Job: LOT 60_F1 FRAMING REFRESHED_11132025 - 1252099
F05

Original Job: LOT 60_F1 FRAMING REFRESHED_11132025

PROBLEM:

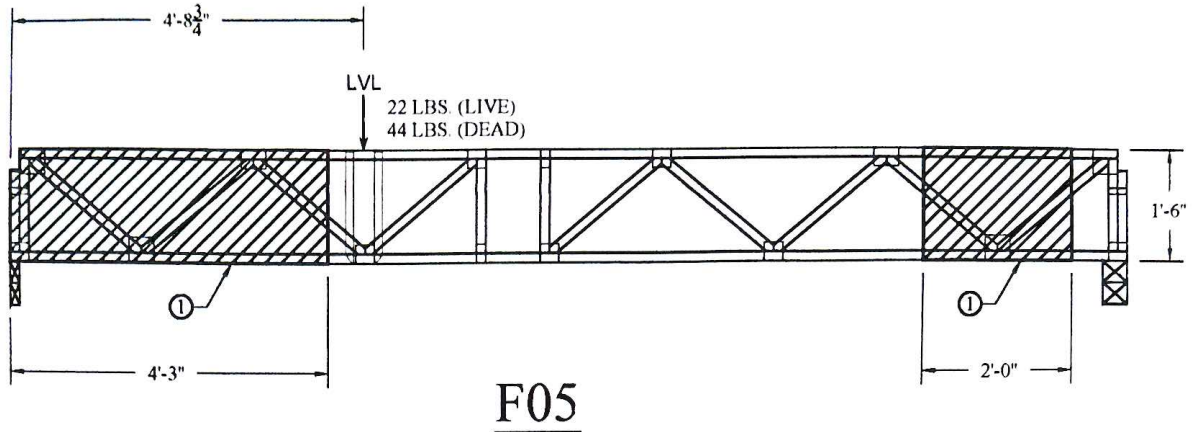
THE F05 TRUSS WAS INSTALLED IN THE LOCATION INTENDED FOR FG01. A 2-PLY LVL BY OTHERS IS HANGERED TO F05. LOCATED 4'-8-3/4" FROM THE LEFT END AS SHOWN. THE LVL BY OTHERS ALSO HAS CONTINUOUS BEARING FROM A WALL BELOW.

1. ATTACH (1) 2-PLY 3/4" PLYWOOD TO TRUSS WITH CONSTRUCTION GRADE WATERPROOF GLUE (PL400 OR BETTER) & (1) ROW OF 1/4" x 4.5" FlatLOK SCREWS AT 4" O.C. TO EVERY CONTACT MEMBER; ONE SIDE ONLY. TYP. (2) LOCATIONS.
